RE: MM Docket No. 92-70
Gadsden State Community College
Station WSGN(FM)
Gadsden, Alabama
BPED-860307MK

A M E N D M E N T

TECHNICAL EXHIBIT
AMENDMENT TO
APPLICATION FOR CONSTRUCTION PERMIT
GADSDEN STATE COMMUNITY COLLEGE
RADIO STATION WSGN(FM)
GADSDEN, ALABAMA

The purpose of this amendment is to eliminate prohibited contour overlap between the proposed WSGN(FM) facility and the proposed new FM station on channel 217A at Oxford, Alabama (FCC File No. BPED-860512MB). In order to eliminate this overlap, Gadsden is proposing the use of channel 218C3 instead of 217C2 and will use a directional antenna to avoid prohibited overlap with the proposed Oxford station and other pertinent FM facilities. The proposal for modified facilities, as amended herein, is considered a major change for FCC processing purposes

**PROPOSED HORIZONTAL PLANE RADIATION PATTERN ENVELOPE
(Relative Field)**

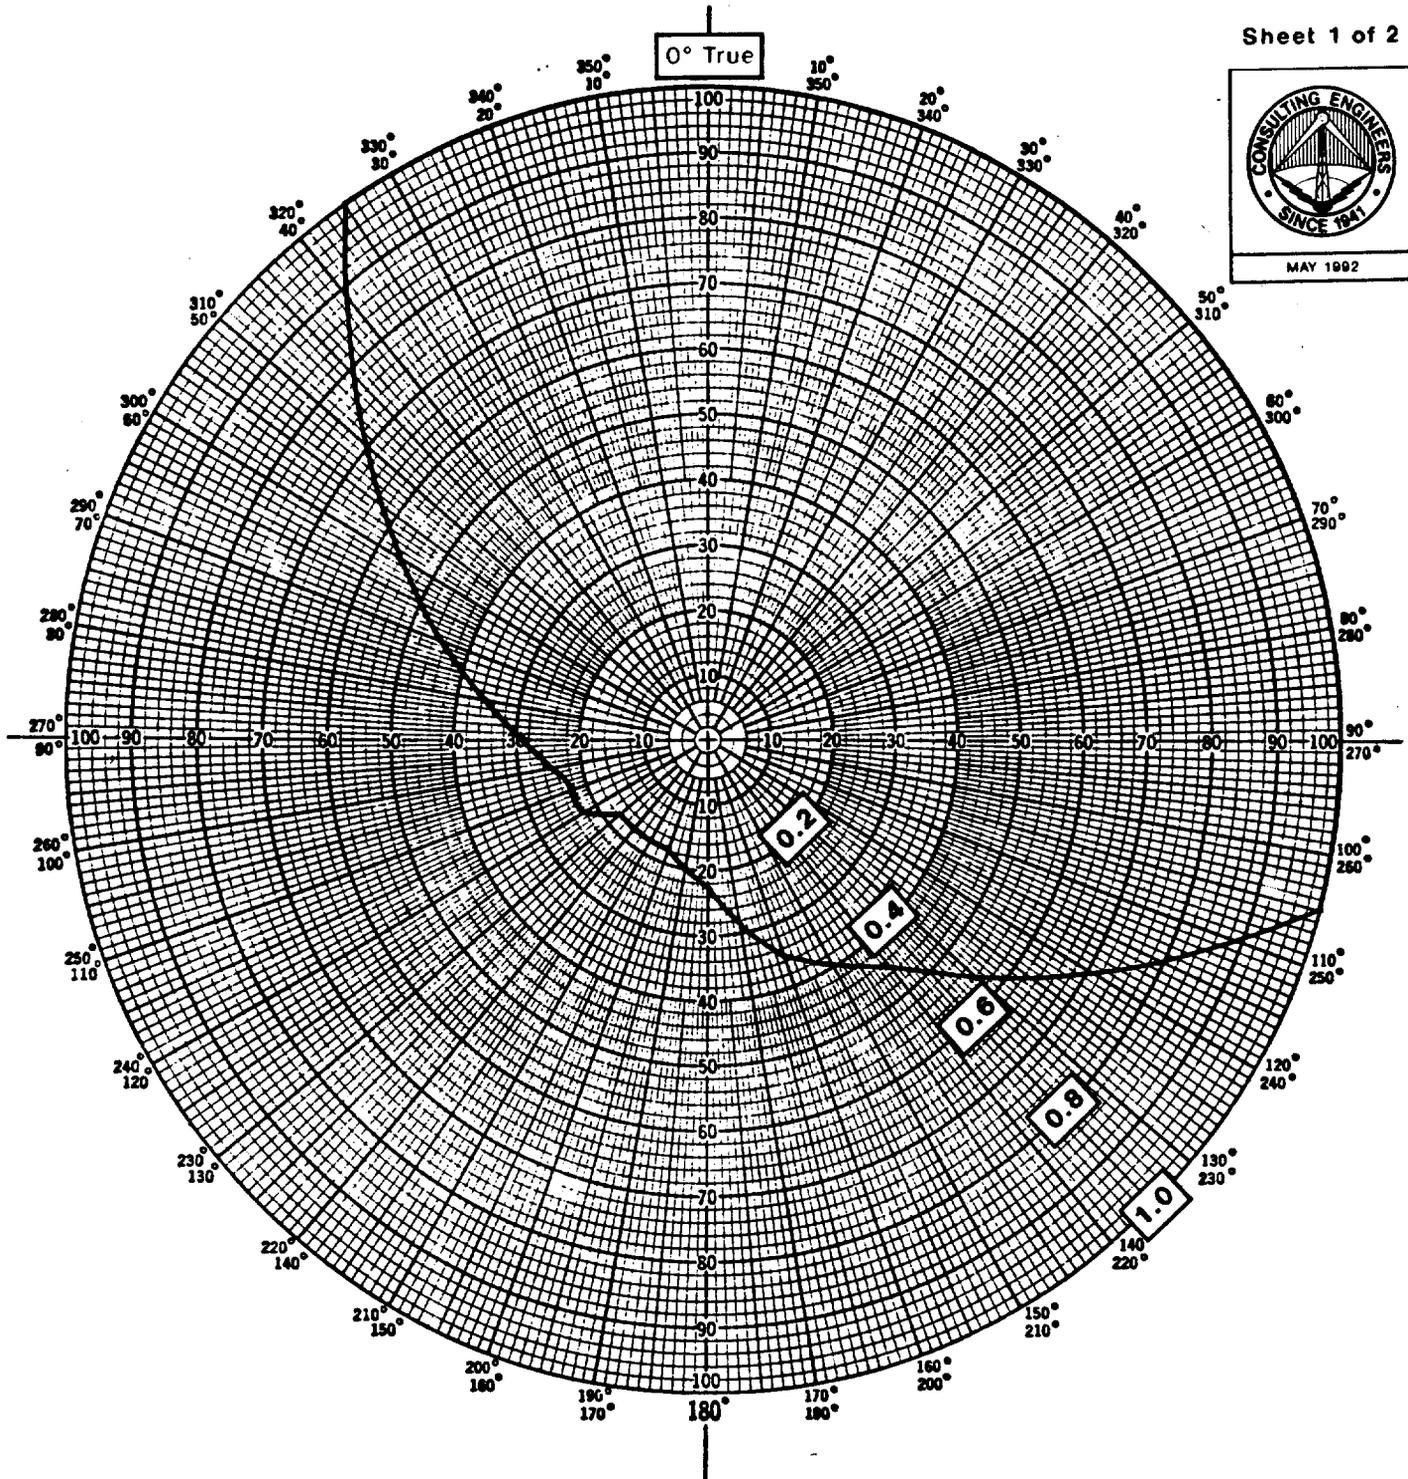
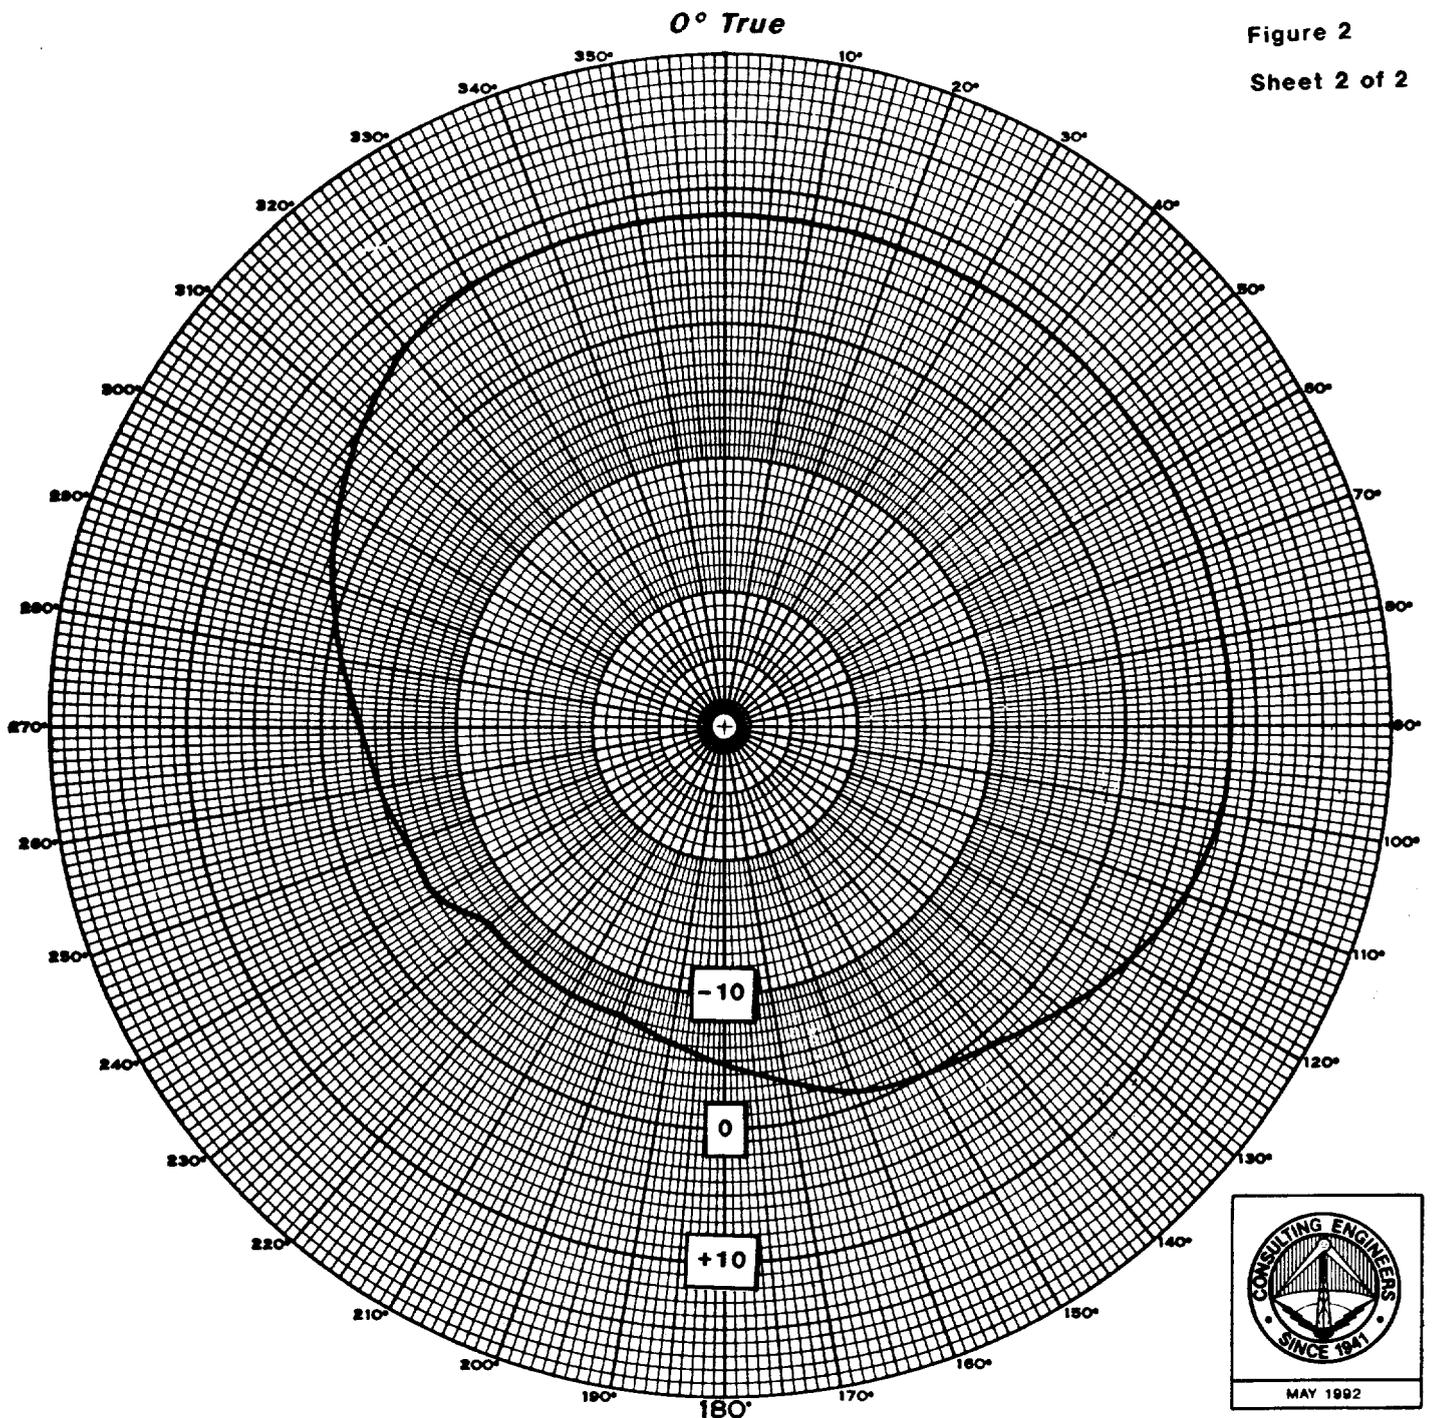
A directional antenna is proposed for use by WSGN(FM) in order to eliminate prohibited contour overlap between the WSGN(FM) proposal and the proposed, new

Oxford, Alabama facility (FCC File No. BPED-860512MB). Graphs of the proposed horizontal plane radiation pattern envelope are included herein as Figure 2, and tabulations of the pattern envelope relative field and effective radiated power are included herein as Figure 3.

The directional antenna ultimately constructed will be custom designed to maintain the radiation within the proposed pattern envelope. Details concerning the directional antenna will be supplied with the WSGN(FM) application for license. The proposed antenna will be side-mounted on the existing tower in accordance with specific instructions provided by the manufacturer. No other antennas will be mounted on the tower at the same level as the proposed antenna, nor will any antennas be mounted within the distance specified by the manufacturer for proper directional operation.
